TENDER COB22-12

ADDENDUM NO 1

Project Name: CHA Standby Power Systems – HA Johnson Manor 9 Church Street

ADD #: 1E

SKETCH NAME:
**CONCRETE PAD
 CONSTRUCTION NOTES
 AND BOLLARD DETAIL**

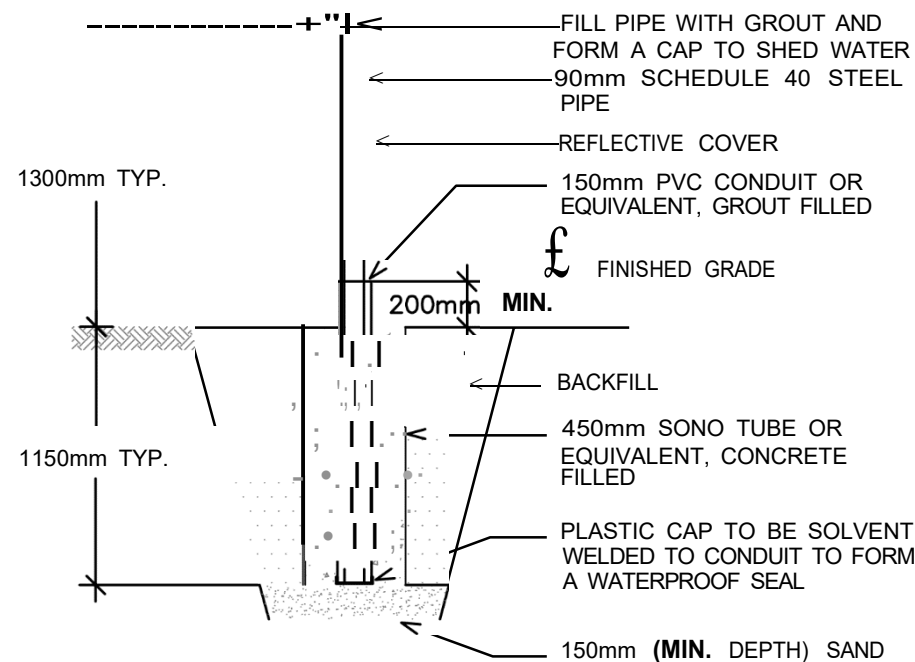
E-1	<ul style="list-style-type: none"> Clarification: There are no fencing requirements for new generator. Bollards for new propane tanks shall be 90mm diameter schedule 40 steel complete with reflective cover above grade. Use 450mm concrete filled sonotube below grade. Refer to sketch SKE-01 for bollard detail. Refer to sketch SKE-01 for concrete pad construction notes. Allow for one (1) additional 27mm rigid PVC conduit from new generator back to existing electrical room.
-----	--------------------------------------------------------------------------------------------------------------------------------------------------------------------------------------------------------------------------------------------------------------------------------------------------------------------------------------------------------------------------------------------------------------------------------------------------------------------------------------------------------------------------------------

SKE-02 PARTIAL SECOND FLOOR PLAN - NEW WORK

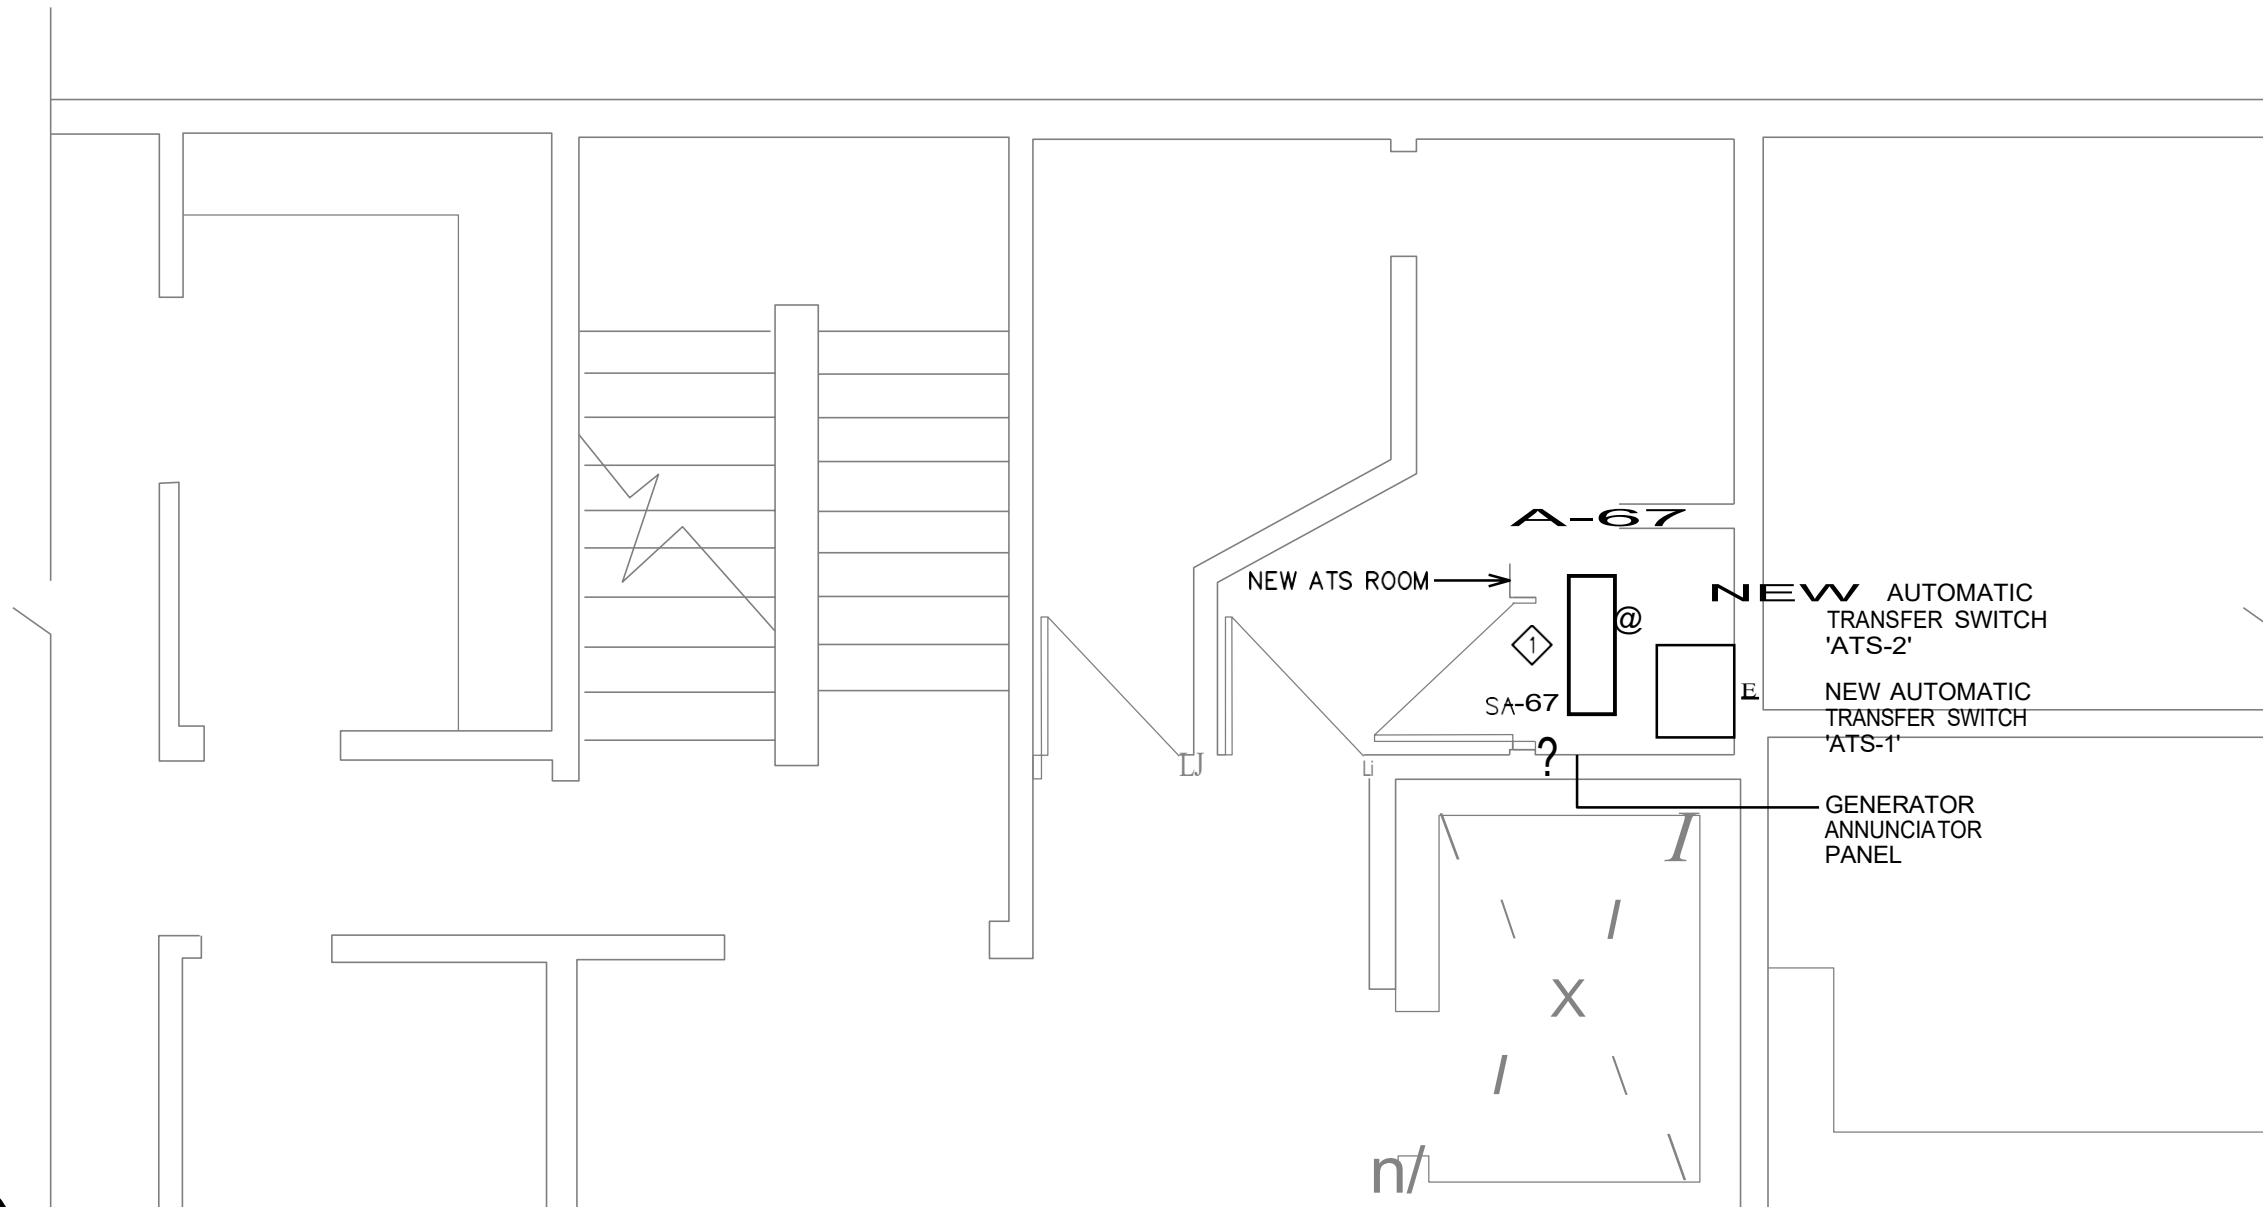
E-2	<ul style="list-style-type: none">• Clarification: There are no fire rated construction requirements for new ATS room.• Clarification: There are no ventilation requirements for new ATS room.• Replace existing gypsum board on ceiling which covers area of new ATS room with new type-X gypsum board.• Extend existing sprinkler system to new ATS room. Supply and install one (1) new sprinkler head, type as specified in sketch SKE-02. Refer to sketch SKE-02 for exact location of new sprinkler head in new ceiling.• New ATS room shall be made of steel stud construction complete with 16mm type-X gypsum board. Patch and paint new gypsum board to match existing conditions.• New door along with door frame for ATS room shall be wood construction. Wood door shall be 1 3/4" thickness with dimensions of 3'-0" x 6'-8". Patch and paint to match existing conditions.
E-3	<ul style="list-style-type: none">• Contractor shall sever source and load ends of existing elevator feeder and terminate conductors in new accessible junction boxes. Intervening portion shall be replaced with new conductors in new conduit as specified. Remainder of existing feed to remain.

CONTRACTOR SHALL REPLACE EXISTING DRYWALL CEILING IN LOCATION OF NEW ATS ROOM WITH NEW TYPE-X GYPSIUM BOARD. NEW ATS ROOM WALLS SHALL BE MADE OF STEEL STUD CONSTRUCTION C/W TYPE-X GYPSIUM BOARD. PATCH AND PAINT TO MATCH EXISTING ROOM.

CONTRACTOR SHALL PROVIDE ALL LABOUR AND MATERIALS TO EXTEND EXISTING SPRINKLER SYSTEM TO NEW ATS ROOM. SUPPLY AND INSTALL ONE (1) NEW SPRINKLER HEAD.

SKETCH NAME:
**CONCRETE PAD
 CONSTRUCTION NOTES
 AND BOLLARD DETAIL**

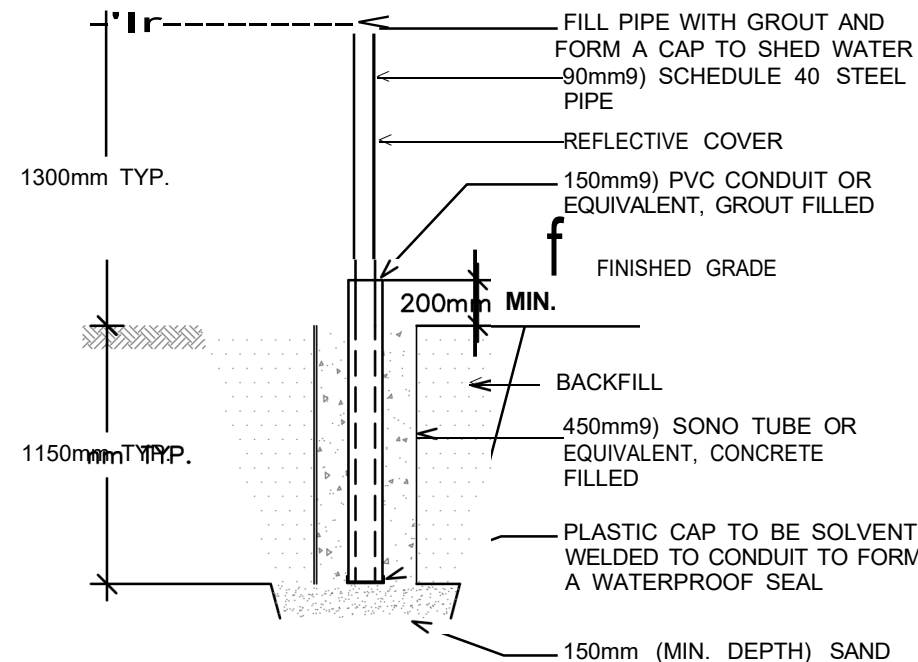
E-1, E-2	<ul style="list-style-type: none"> Clarification: There are no fencing requirements for new generator or new propane tanks. Bollards for new propane tanks shall be 90mm diameter schedule 40 steel complete with reflective cover above grade. Use 450mm concrete filled sonotube below grade. Refer to sketch SKE-01 for bollard detail. Refer to sketch SKE-01 for concrete pad construction notes. Concrete pad construction notes shall apply to concrete pad for new propane tanks and new generator. New concrete pad for new propane tanks shall have dimensions of 3.6m x 5.2m. Confirm dimensions of new concrete pad with Irving Energy. Refer to sketch SKE-02 for details. Clarification: Propane piping from new generator to new propane tank shall be supplied and installed by Irving Energy. Refer to sketch SKE-02 for details. Refer to sketch SKE-02 for updated locations of new generator and new propane tanks. Coordinate on site for exact locations.

SKETCH NAME:
ELECTRICAL SITE DETAILS

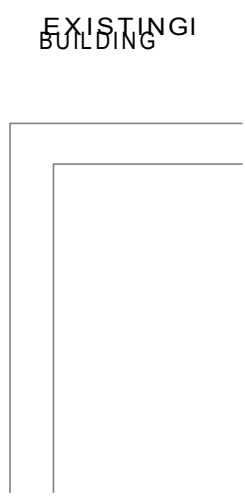
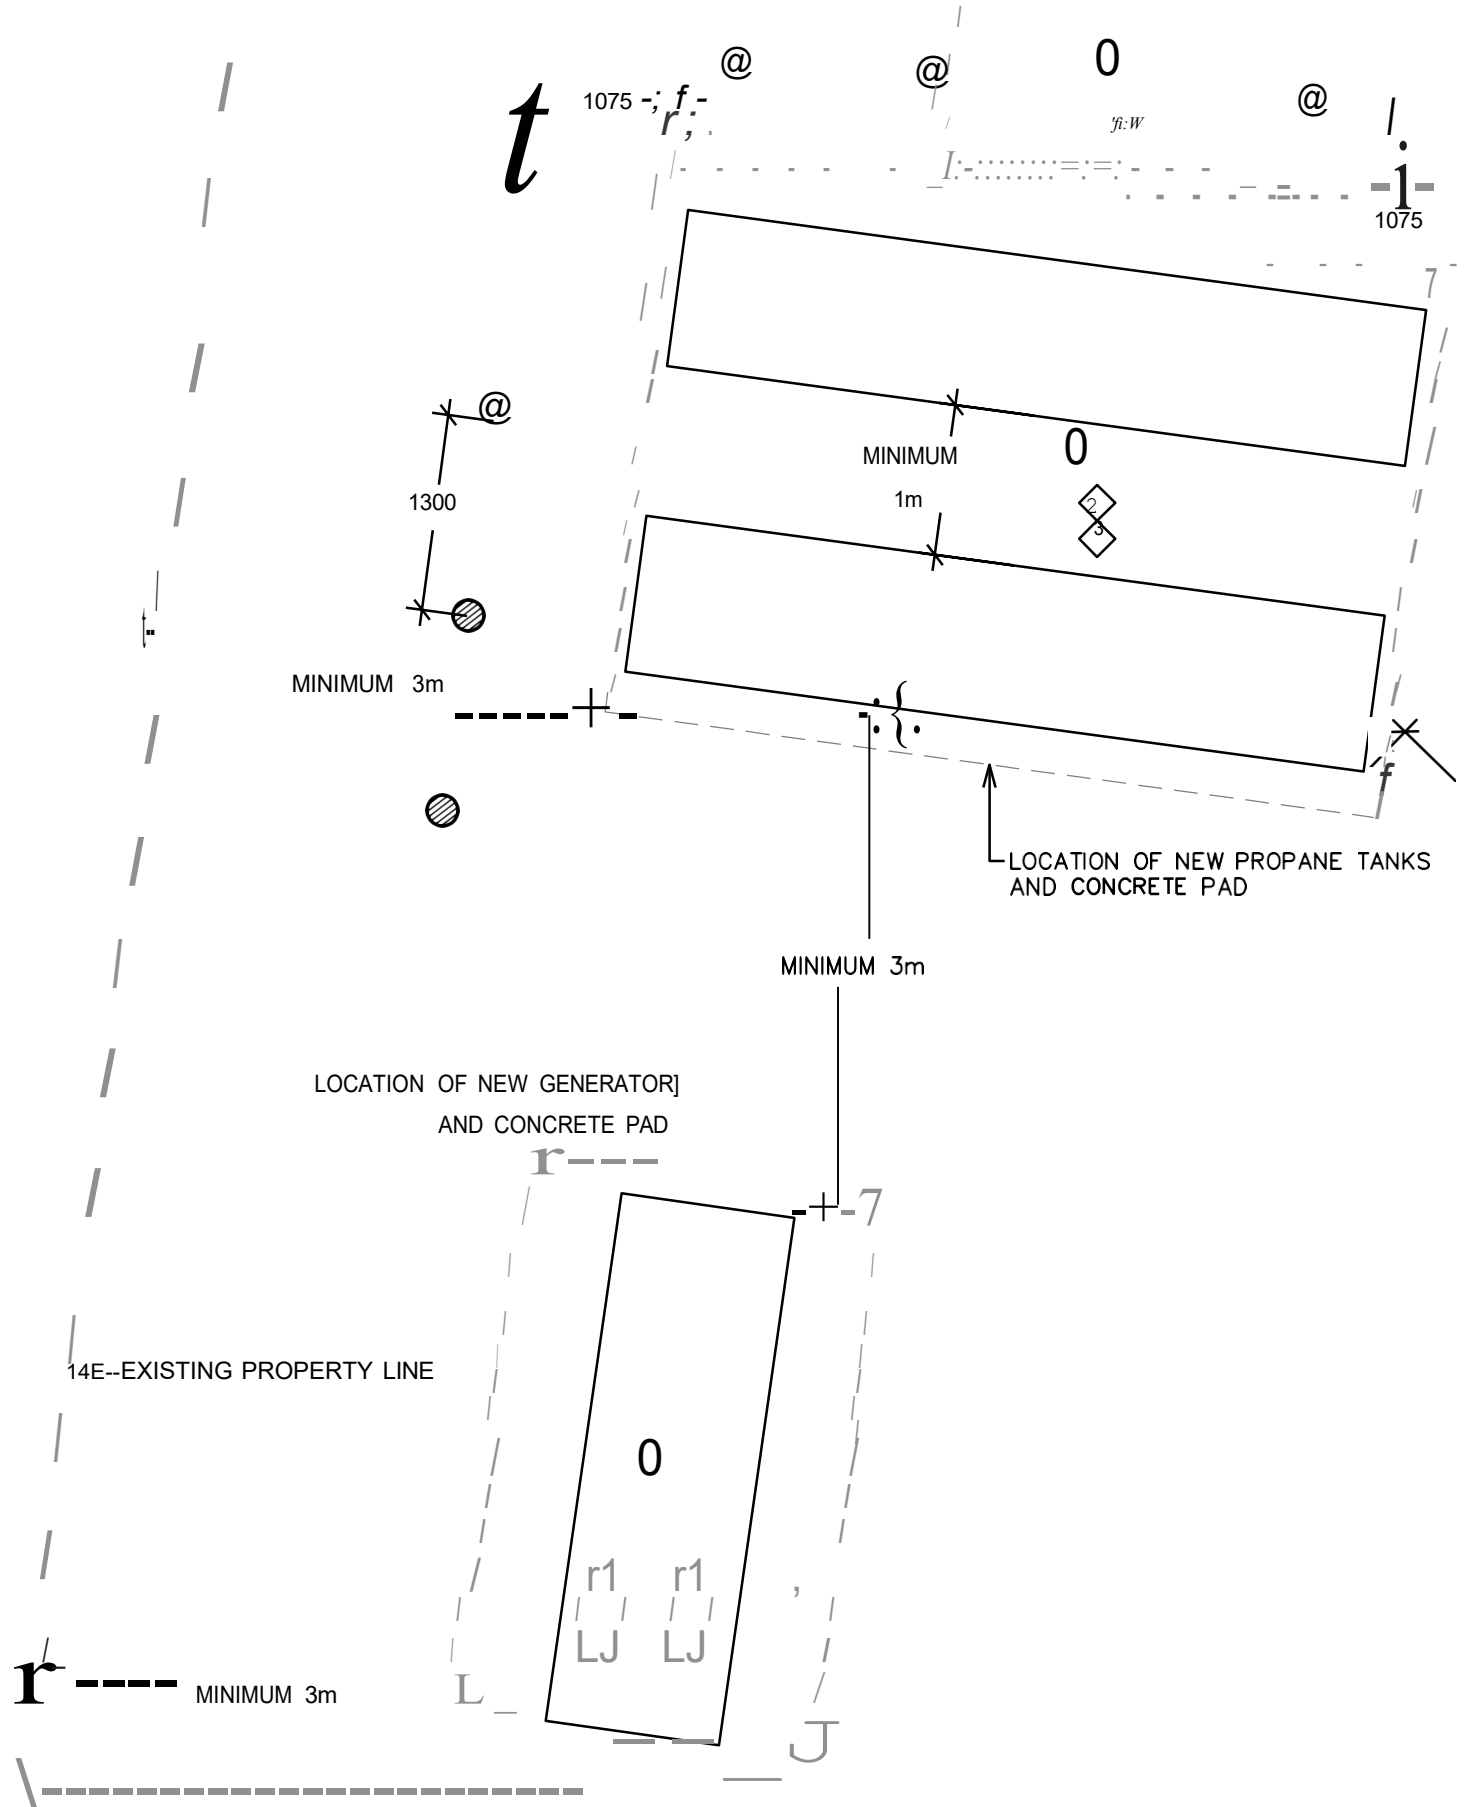
- SPECIFIC NOTES:**
- 0 NEW CONCRETE PAD FOR PROPANE TANKS SHALL HAVE DIMENSIONS OF NEW CONCRETE PAD WITH IRVING DIMENSIONS OF 3.6m X 5.2m. CONFIRM EXACT ENERGY.

- 0 GENERATOR SHALL BE SUPPLIED AND INSTALLED BY PROPANE PIPING FROM NEW PROPANE TANKS TO NEW IRVING ENERGY.
 - 0 MAINTAIN A MINIMUM DISTANCE OF 3m BETWEEN EXISTING PROPERTY BOUNDARY AND LOCATION OF NEW PROPANE TANKS.

- 0 MAINTAIN A MINIMUM DISTANCE OF 3m BETWEEN EXISTING PROPERTY BOUNDARY AND LOCATION OF NEW GENERATOR. ENSURE A MINIMUM DISTANCE OF 3m BETWEEN NEW GENERATOR AND EXISTING PAD TRANSFORMER. REFER TO ORIGINAL CONTRACT DRAWINGS FOR LOCATION OF EXISTING PAD TRANSFORMER. NEW GENERATOR SHALL BE NO LESS THAN 5m AWAY FROM ANY DOOR OR WINDOW OF EXISTING BUILDING. COORDINATE ON SITE FOR EXACT LOCATION.

- 5 ENSURE A MINIMUM DISTANCE OF 7.5m IS ACHIEVED BETWEEN NEW PROPANE TANKS AND FRONT WINDOW OF EXISTING BUILDING.
 - 6 REMOVE EXISTING CONCRETE TILING AS NECESSARY TO PREPARE FOR SITE WORK. COORDINATE WITH OWNER REPRESENTATIVE FOR RELOCATION OF REMOVED TILING.
